Raleigh Historic Development Commission – Certificate of Appropriateness (COA) Application

APPLICATION FOR A CERTIFICATE OF APPROPRIATENESS – STAFF REPORT

139-17-CA 932 N BOYLAN AVENUE Applicant: MICHAEL LOMBARDO

Nature of Project: Addition of rear dormer

ELEVATIONS

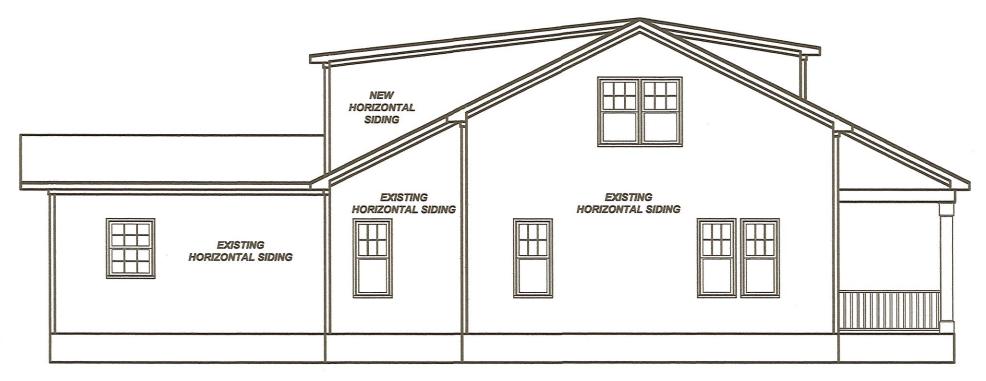
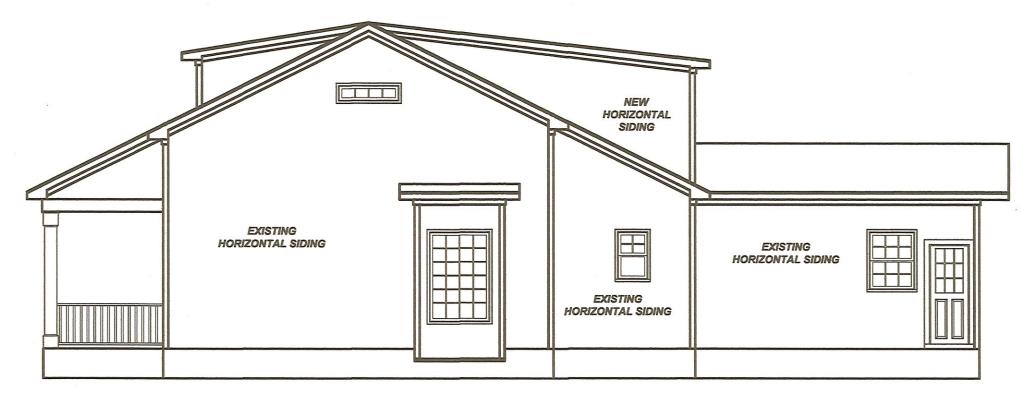
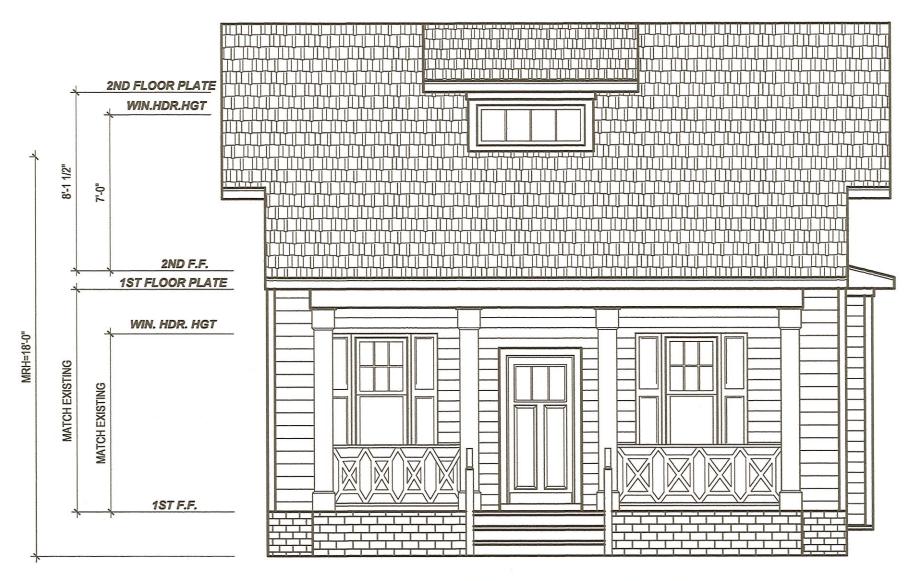
• Measured scaled drawings of the existing house and your proposed changes. This will be especially important for the elevations, and labeling them so that it's clear what is changing.

6* New rear-facing windows are proposed to be single-hung to match the existing. Details and specifications were not provided.

Measured scaled drawings are included in package.

- 1. That details and specifications for the following be provided to and approved by staff prior to the issuance of the blue placard:
 - a. Eave construction;
 - b. Windows.
- 2. That the fiber-cement siding be installed with the smooth finish facing out.

FIRST FLOOR

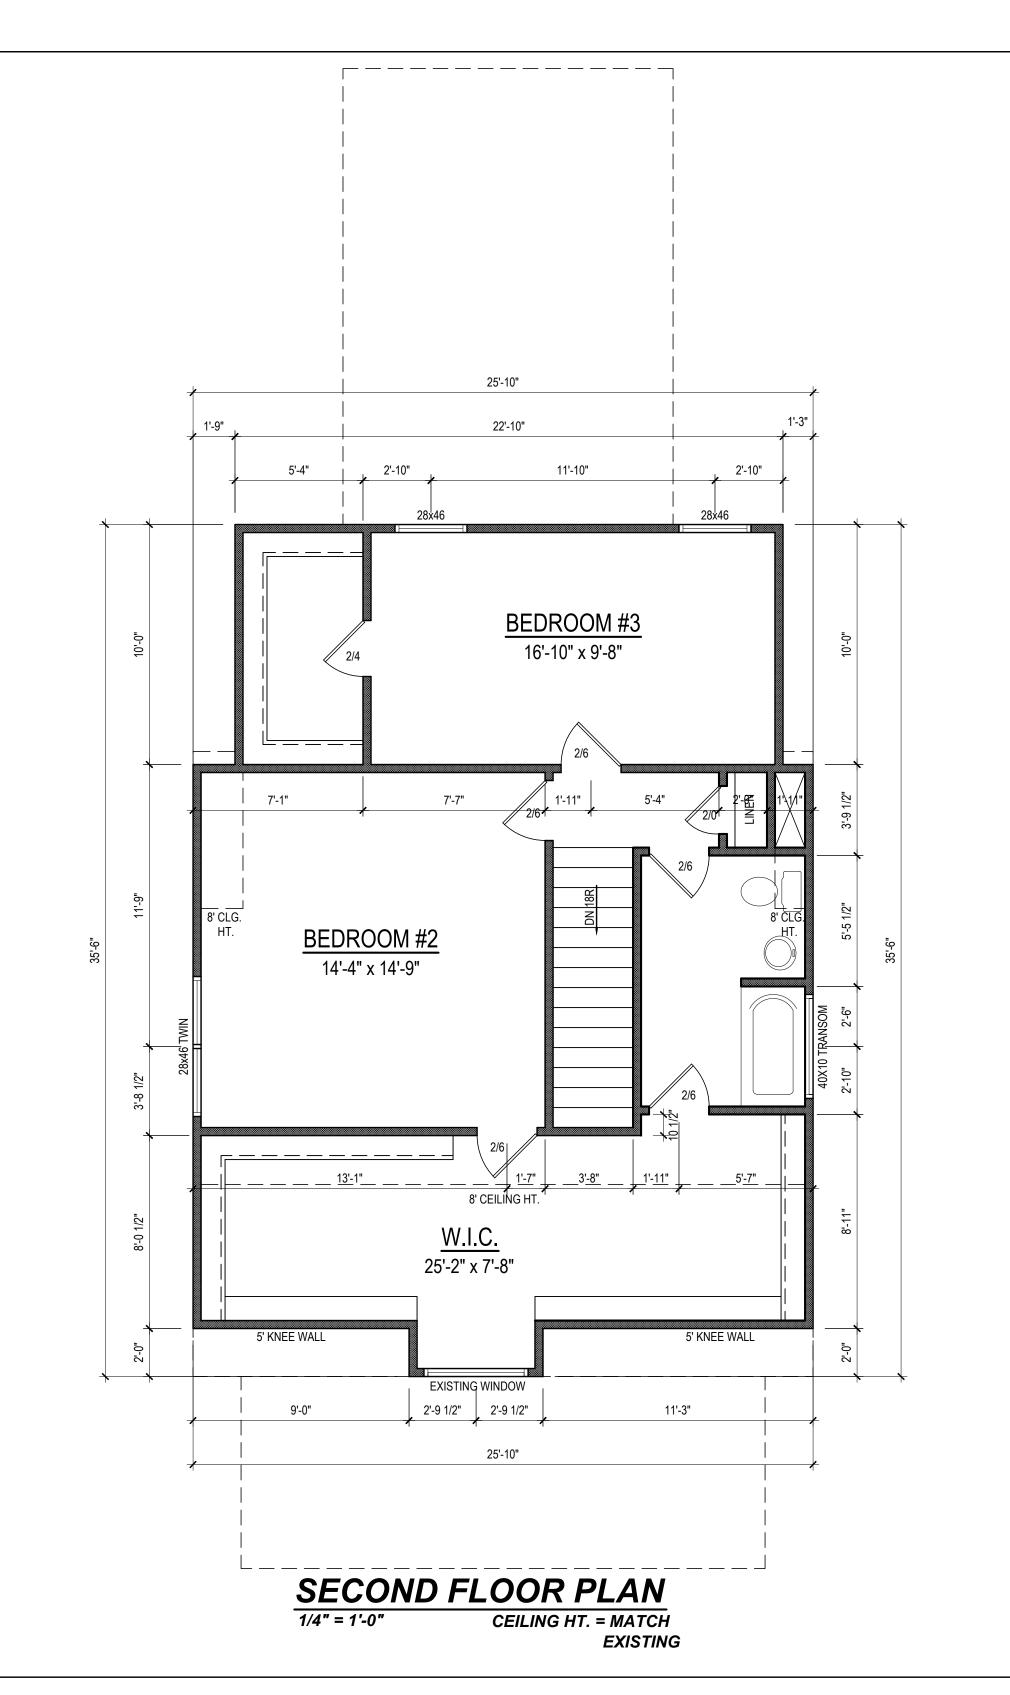
Since your drawings did not provide any dimensions, we did a quick estimation that the first 50% of the house (not including the front porch) would be roughly through the refrigerator. So anything affecting the house exterior from that point forward will need a COA. You can find the application here.

A ground floor plan that shows where the first 50% of the house ends.

Included in package

ROOF PLAN

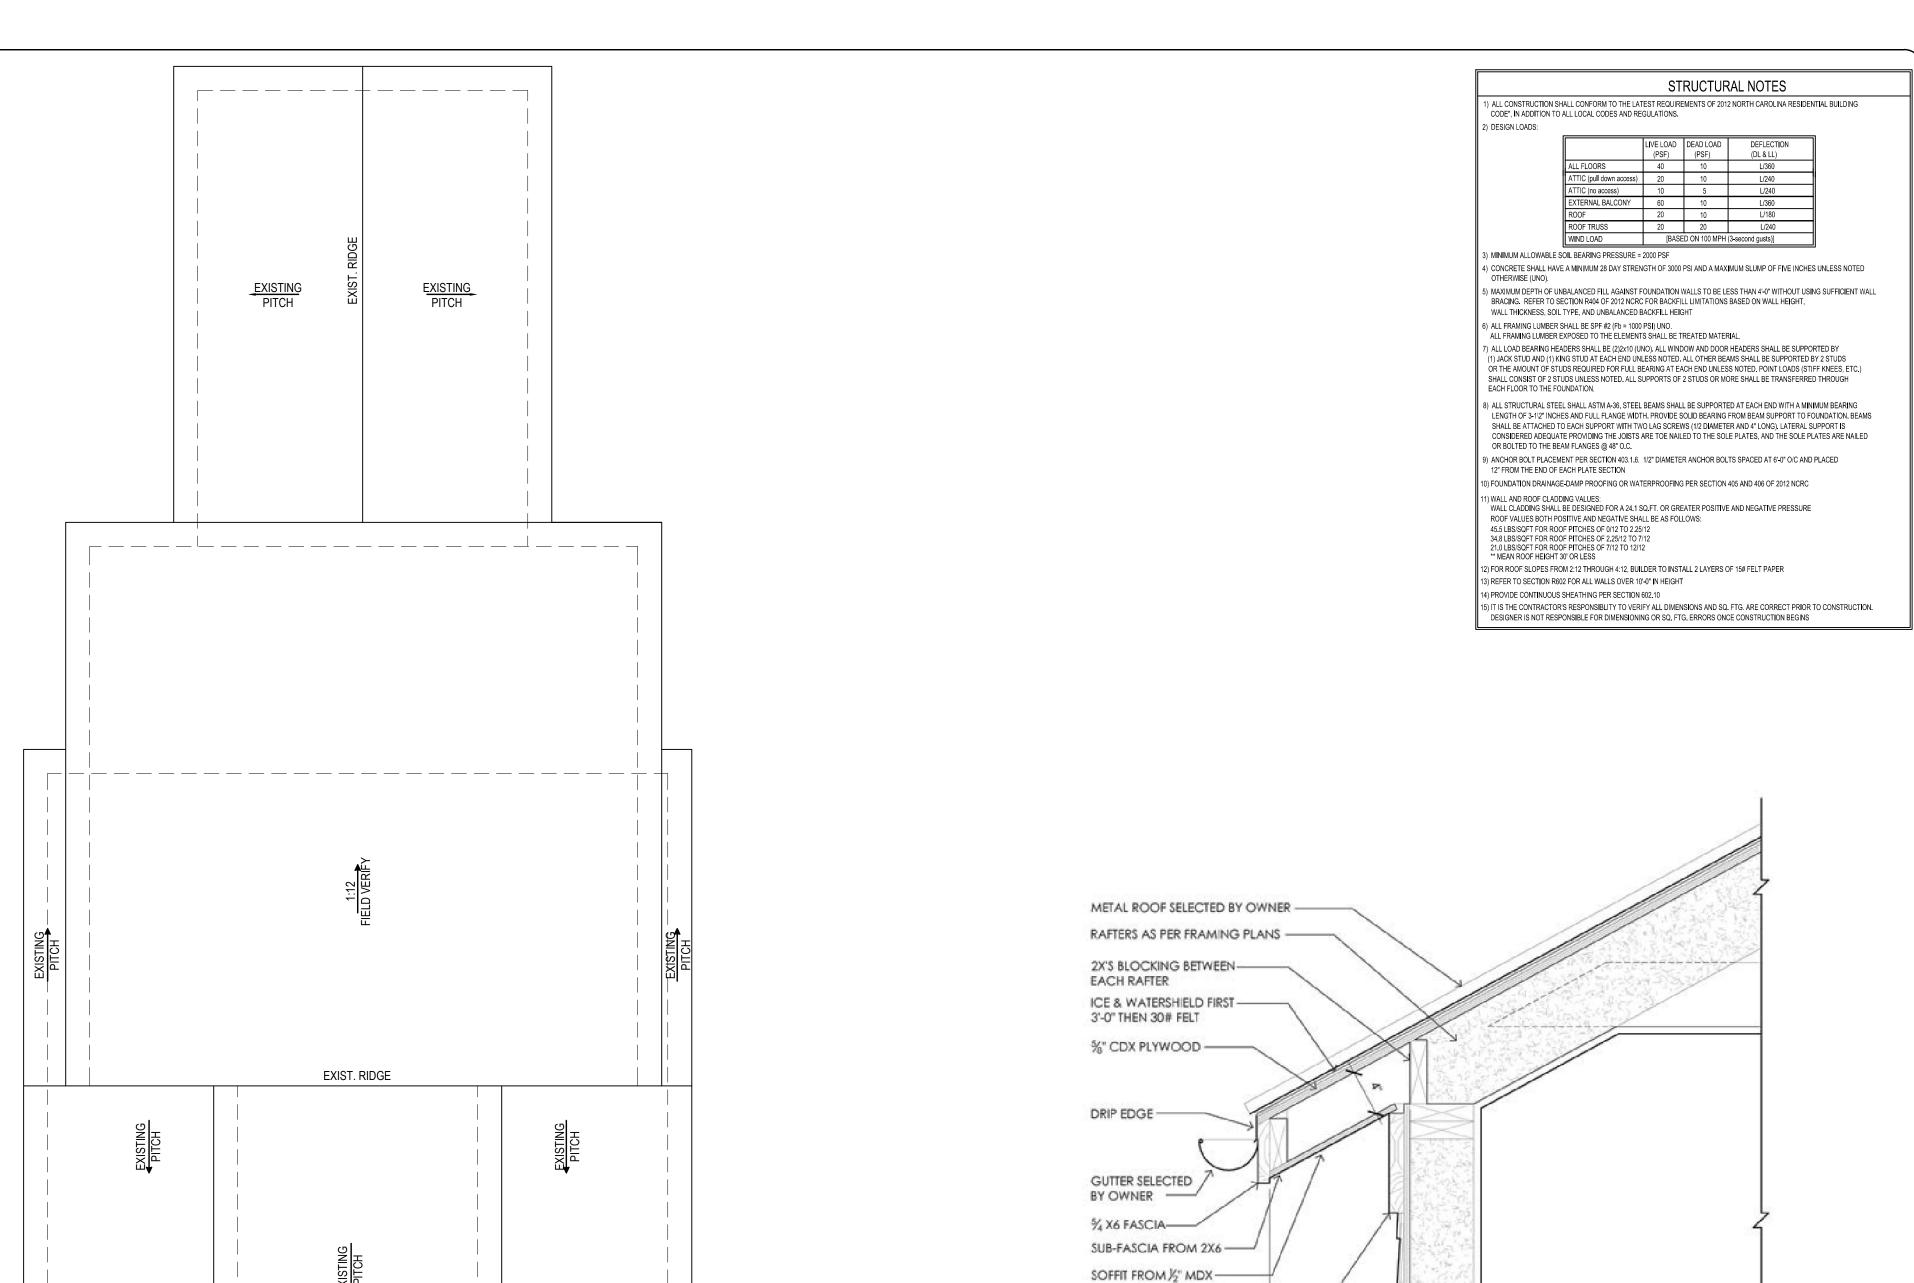
It would also help to have a roof plan.

INCLUDED
